CALIFORNIA COASTAL COMMISSION

REGULAR CALENDAR
STAFF REPORT AND PRELIMINARY RECOMMENDATION

Application No.: 6-98-151

Description: Demolition of an existing one-story single family dwelling and garage and construction of a two-story, 24-foot high, 5,675 sq.ft. single-family dwelling and two-story, 785 sq.ft. office/garage on a 1.44 acre site.

EXHIBIT NO. 2
APPLICATION NO.
6-98-151
Site Plan

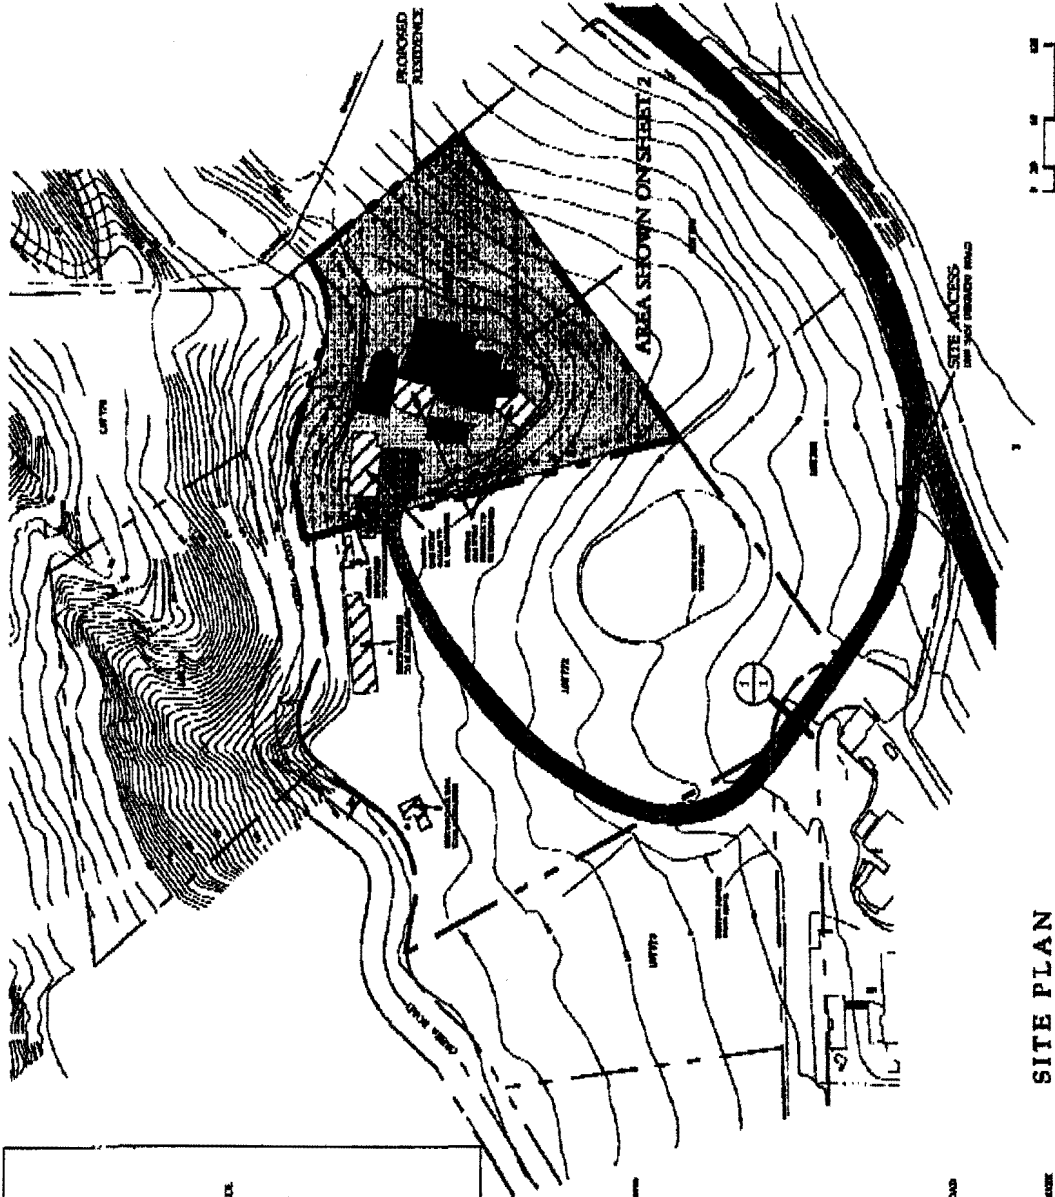
1. Final Plans. Prior to issuance of the coastal development permit, the applicant shall submit to the Executive Director for review and written approval, final plans for the proposed residence and office/garage. Said final plans shall be in substantial conformance with the plans submitted with this application dated October 19, 1998, by Bruce Peeling, Architect. The permittee shall undertake development in accordance with the approved plans. Any proposed changes to the approved plans shall be reported to the Executive Director. No changes to the plans shall occur without a Coastal Commission approved amendment to this coastal development permit unless the Executive Director determines that no amendment is required.

2. Drainage Plan. Prior to the issuance of the coastal development permit, the applicant shall submit for the review and written approval of the Executive Director, a drainage and runoff control plan, with supporting calculations. This plan shall document no increase in peak runoff and that runoff from the roof, driveway and other impervious surfaces will be collected and appropriately discharged. Runoff shall be directed away from the hillside where appropriate, and any runoff directed over the hillside shall be retained and discharged at a non-erosive velocity (less than 6 cfs) and elevation in order to reduce the potential for degradation resulting from scouring or concentrated runoff.

(a) Prior to the issuance of the coastal development permit, the applicant shall submit for the review and written approval of the Executive Director, a detailed landscape plan indicating the type, size, extent and location of all plant materials, the proposed irrigation system and other landscape features. The plan shall include the following:

trees (24-inch box minimum) to be arranged along the east-facing portion of the site to effectively screen the structure from views from San Dieguito Lagoon and Interstate 5.
